MEETING #2 NOTES

- This is the second in a series of four Advisory Committee meetings for the SR 125/SR 32 Focus Area.
- This meeting is intended to be a working meeting. It will focus on reviewing the results of the preliminary studies completed for each concept discussed at the first Advisory Committee meeting; discussing possible refinements to be made to the concepts; and determining whether or not to advance each concept for further study.

Eastern Corridor Segments II and III SR 125/SR 32 Focus Area

Figure I-22B and Elstun-1
NORTHBOUND LEFT TURN LANE AND WESTBOUND RIGHT TURN LANE EXTENDED ON S.R. 125 AND ELSTUN.
SIDEWALK CONNECTION FROM S.R. 125 TO RENTAL PROPERTIES

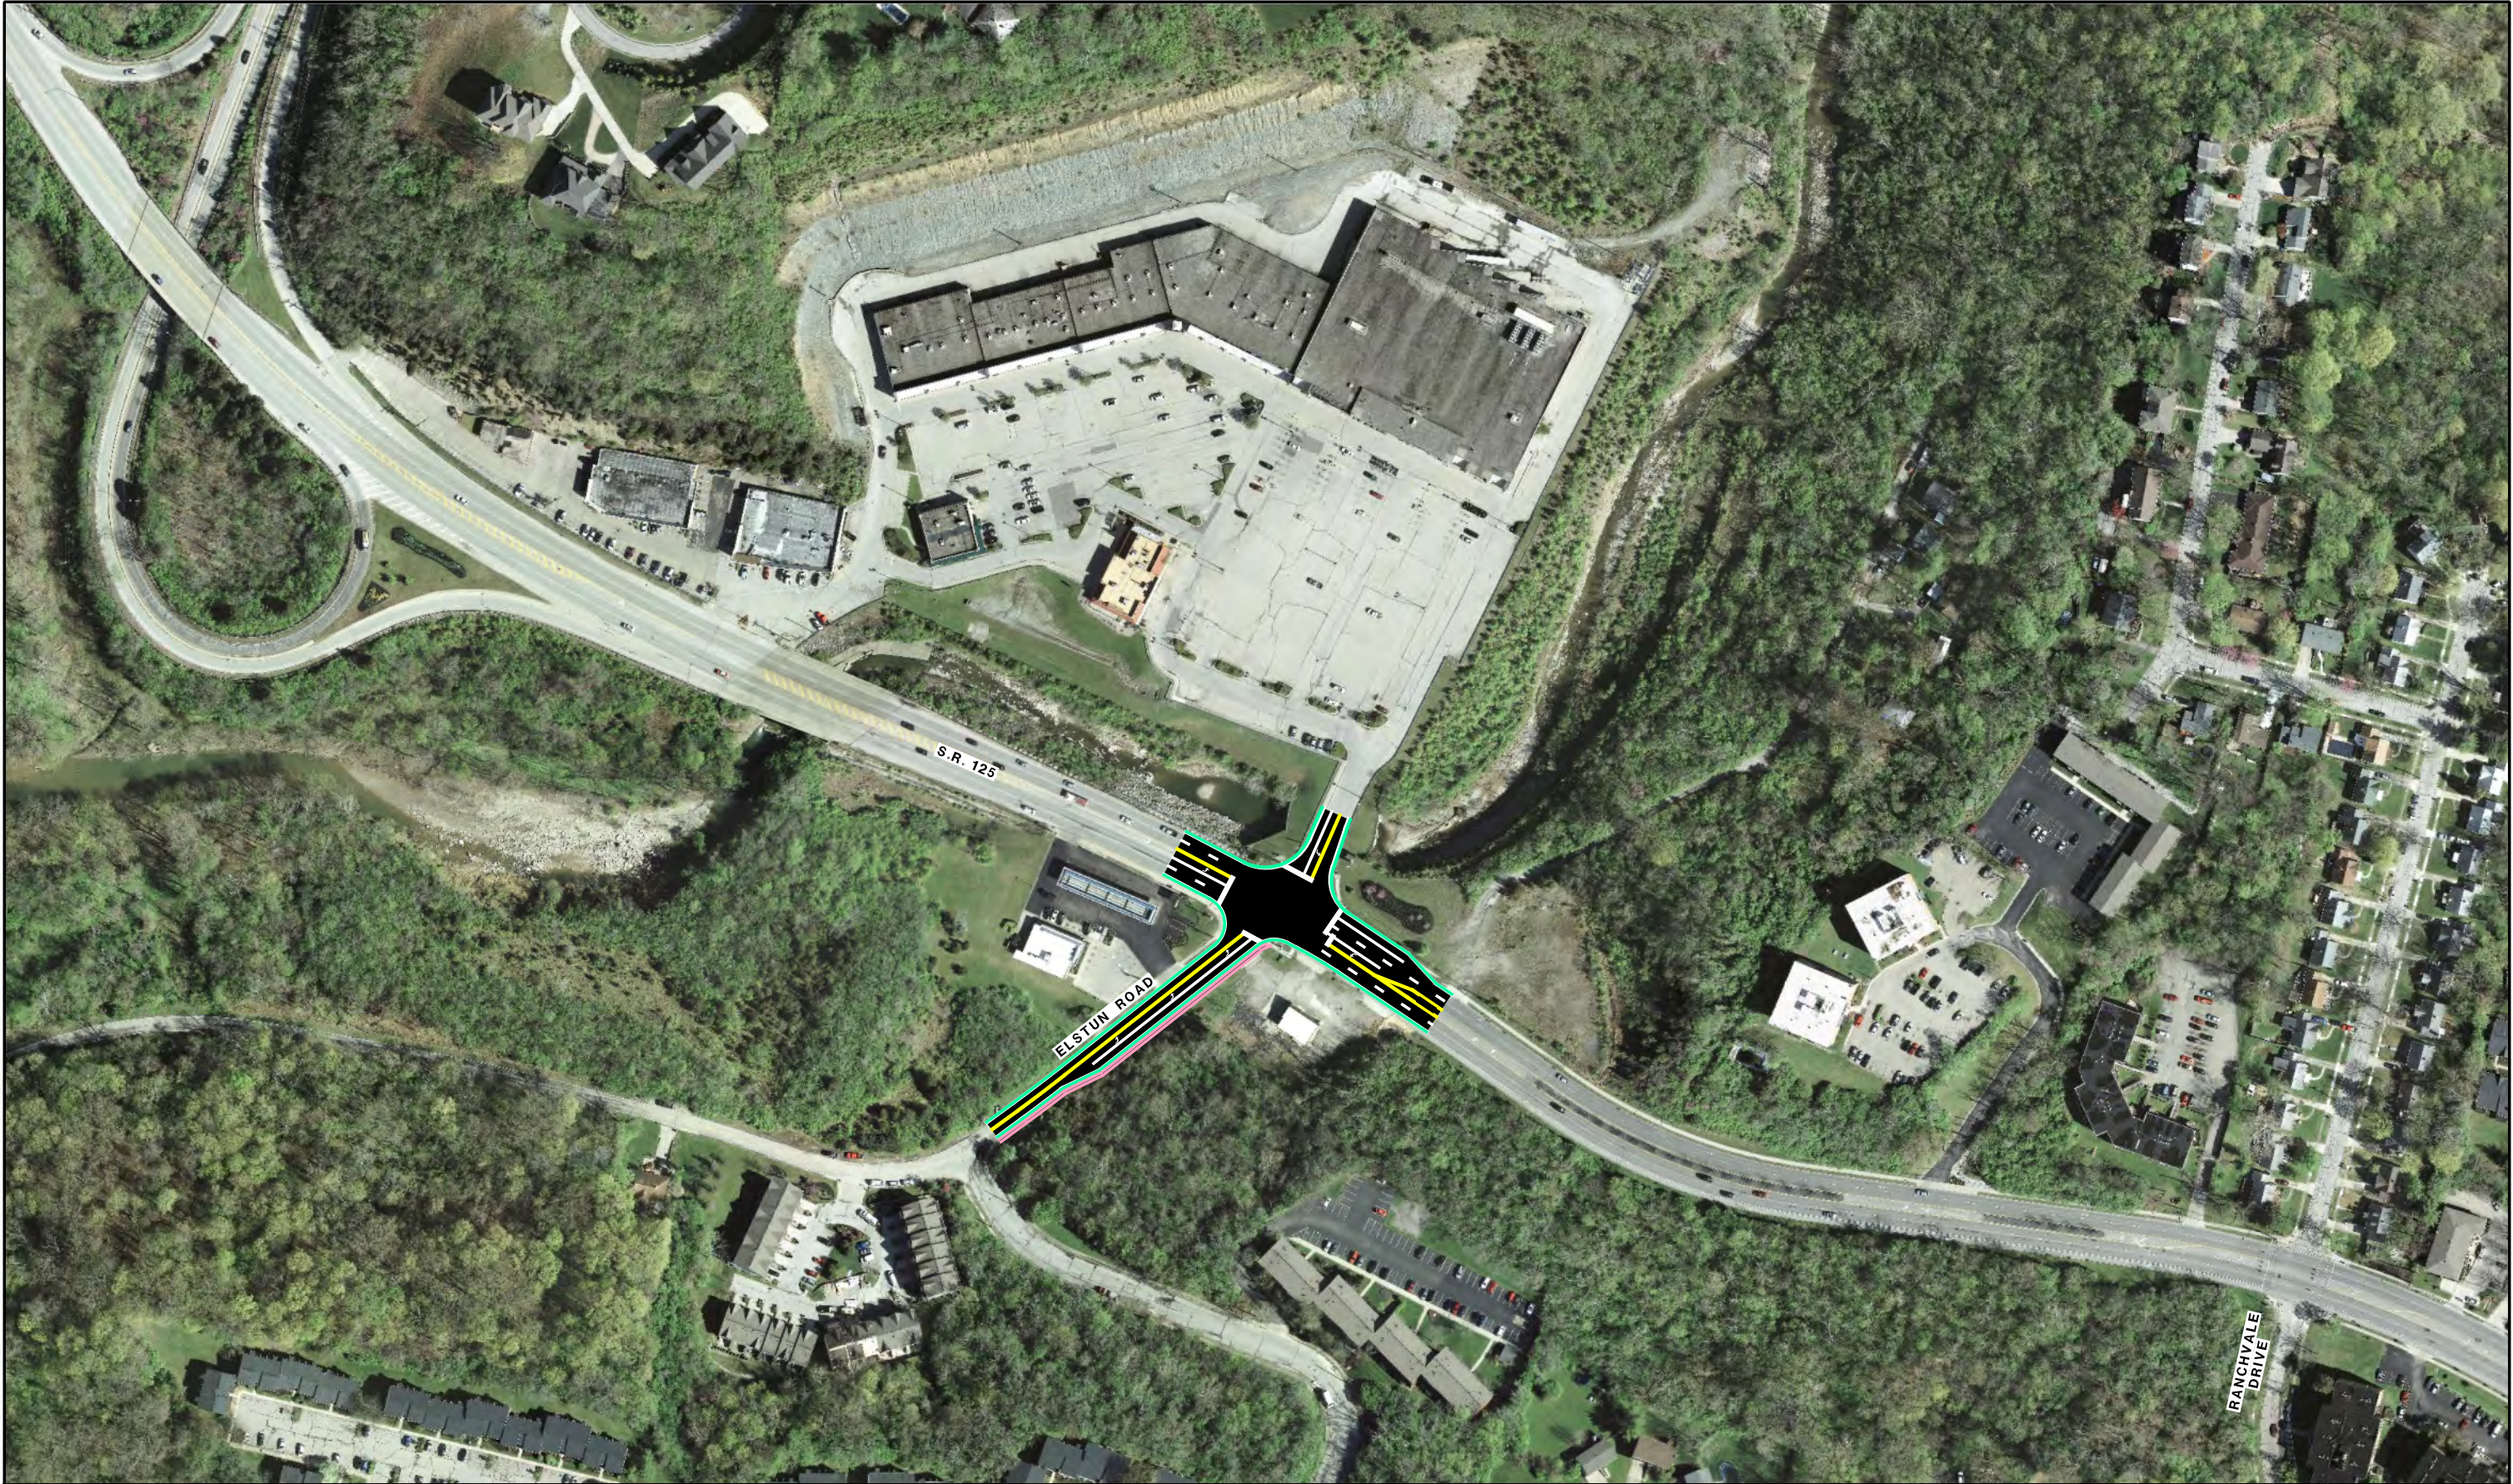
- Initial analysis indicated minimal delay reductions:
 - Approximately 8 percent during morning peak hours
 - Zero percent during evening peak hours
- Consultant evaluated replacing the intersection with a roundabout as suggested in Meeting 1, but the concept (I-22c) did not work:
 - It disrupted traffic flow.
 - Existing topography cannot accommodate a roundabout.
 - A roundabout would better serve the intersection farther west (see Concept X-1g).

- No further study at this time. With proposed development changes at Skytop, any intersection improvements are contingent on development.

Figure 32-1B and 32-2
SHARED USE PATH FROM TURPIN LAKE PLACE AND ROPES DRIVE TO THE LITTLE MIAMI TRAIL

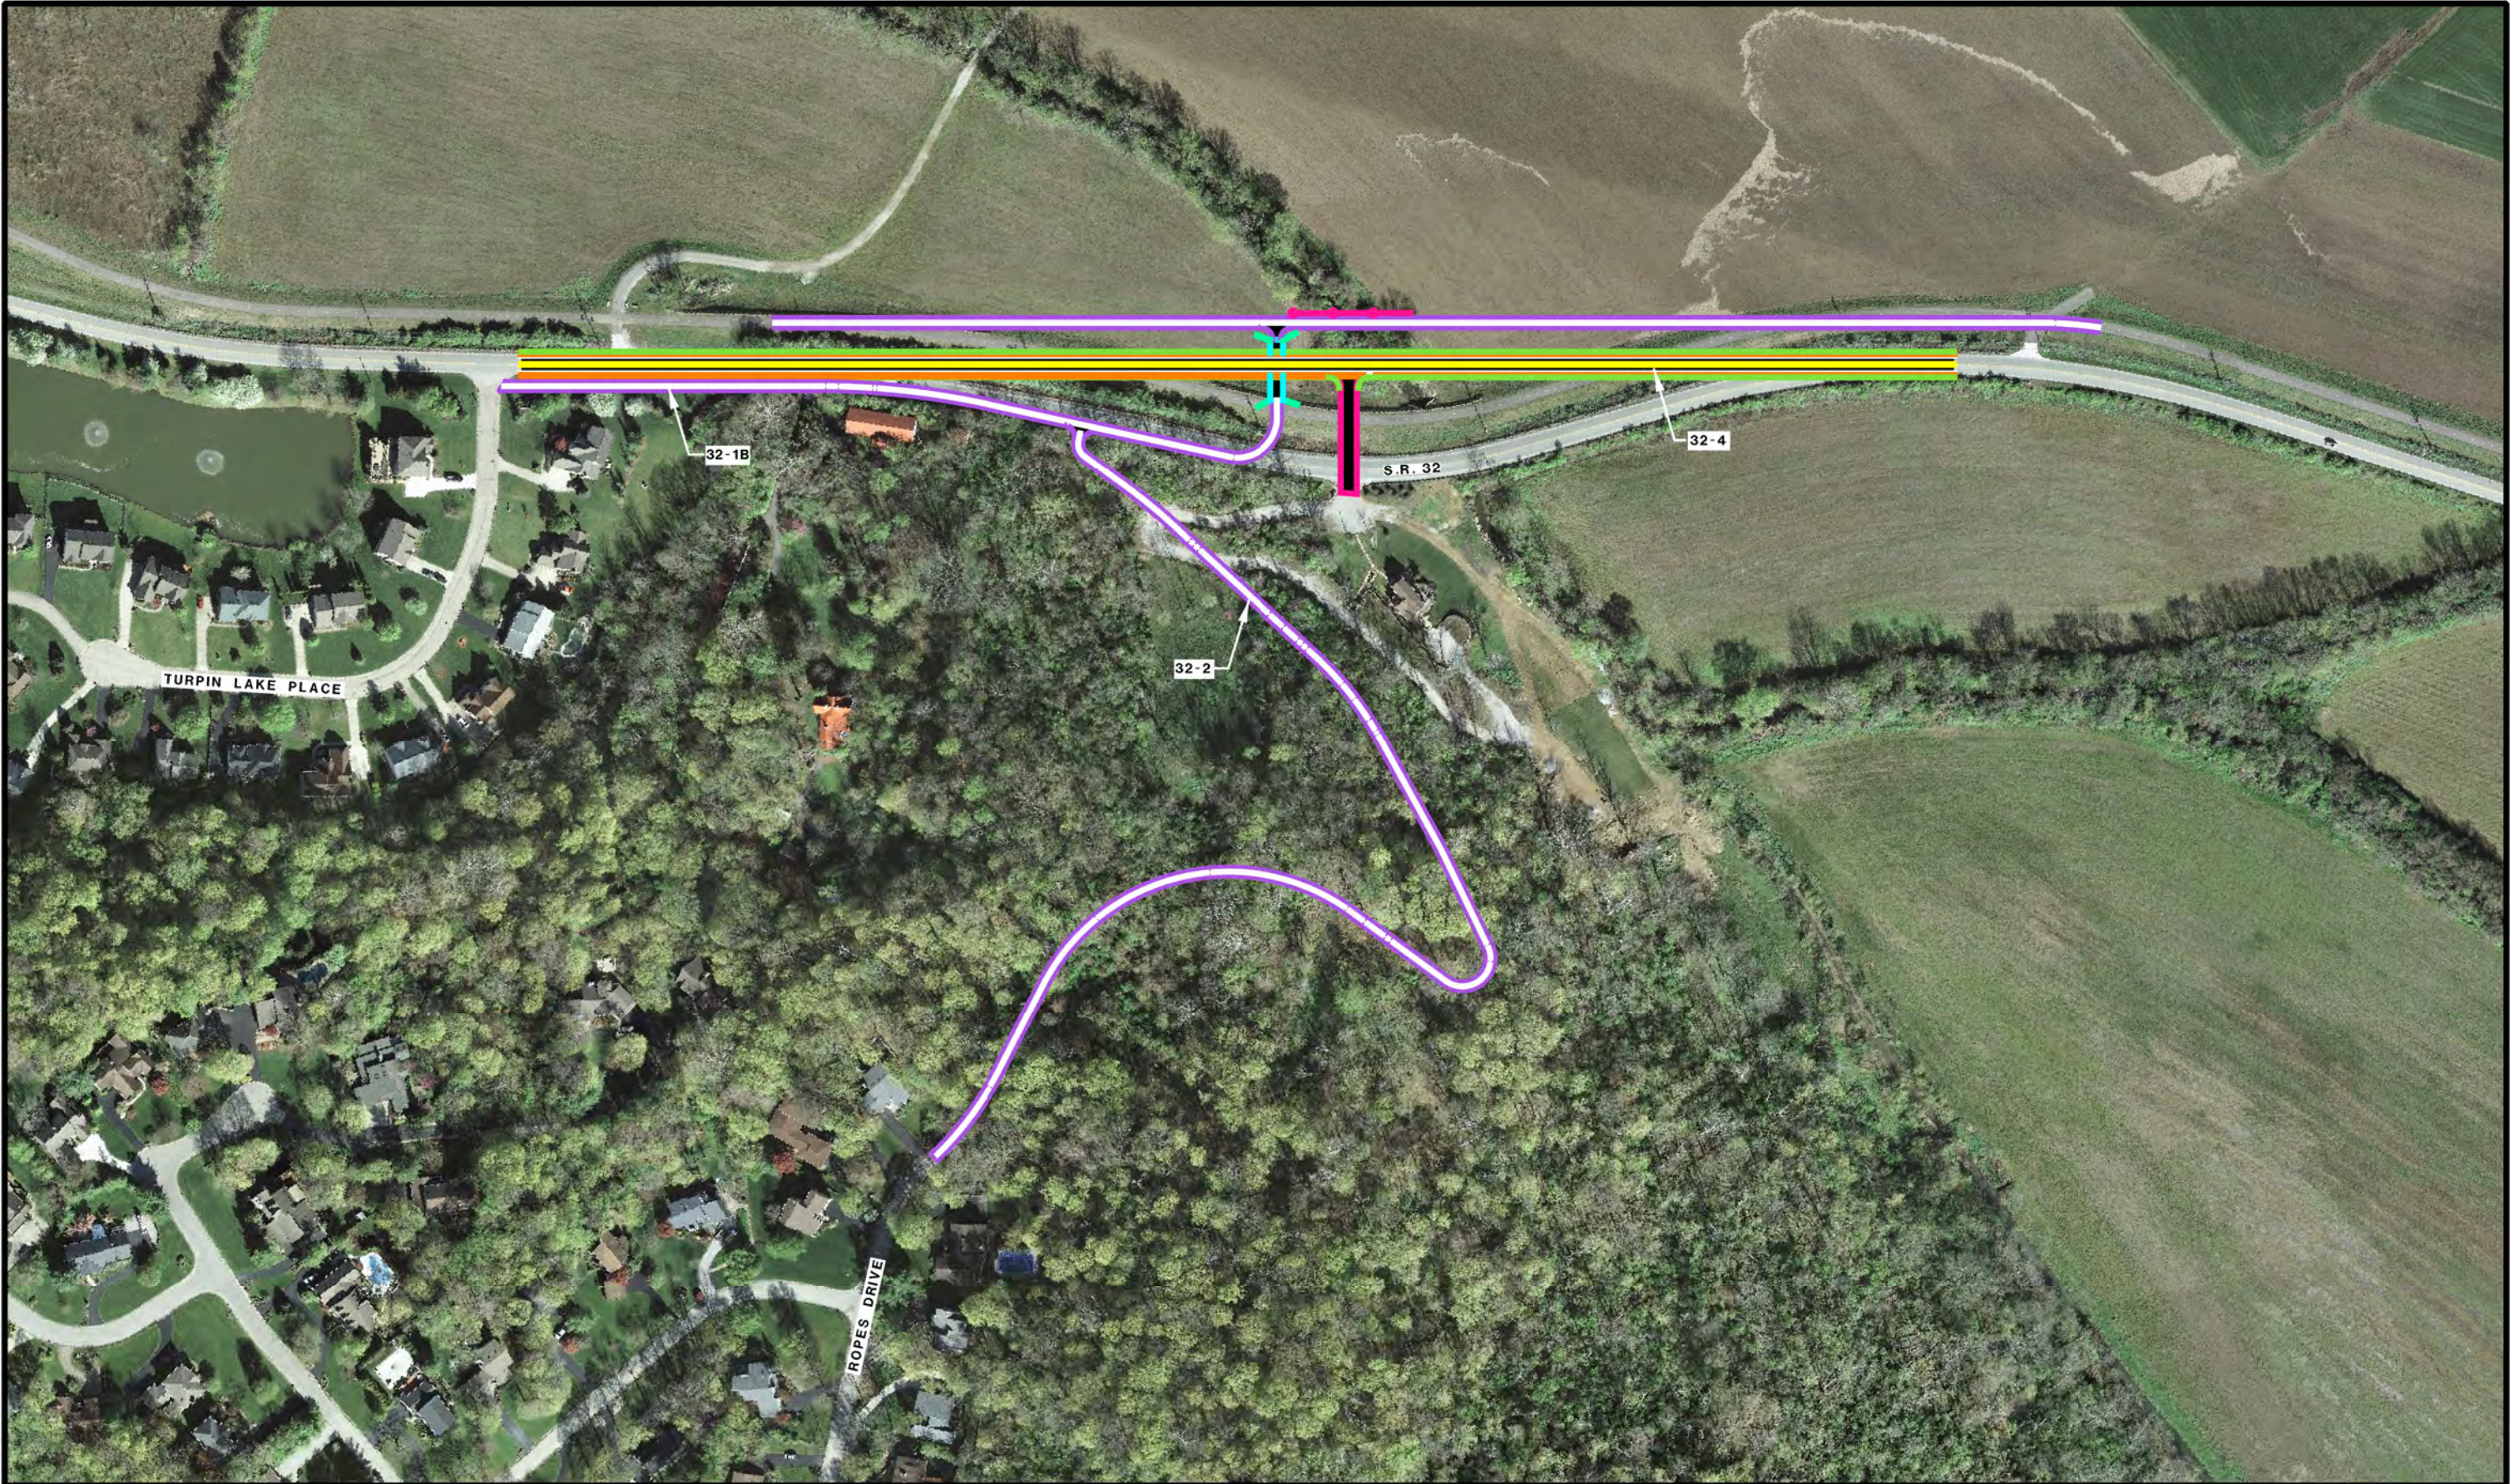
- Provides an at-grade crossing to the Little Miami Trail from Turpin Lake Place.
- Speed of traffic on SR 32 may be a concern for implementation.
 - Perhaps rectangular rapid flashing beacons (RRFB) that advise vehicles to slow down could be installed prior to the crossing. The self-sensing beacons would be activated only when someone is using the crossing.
- This concept primarily benefits Turpin Lake Place residents (and any future bike connections that may be routed along Turpin Lake Place).

- Advance for further study.
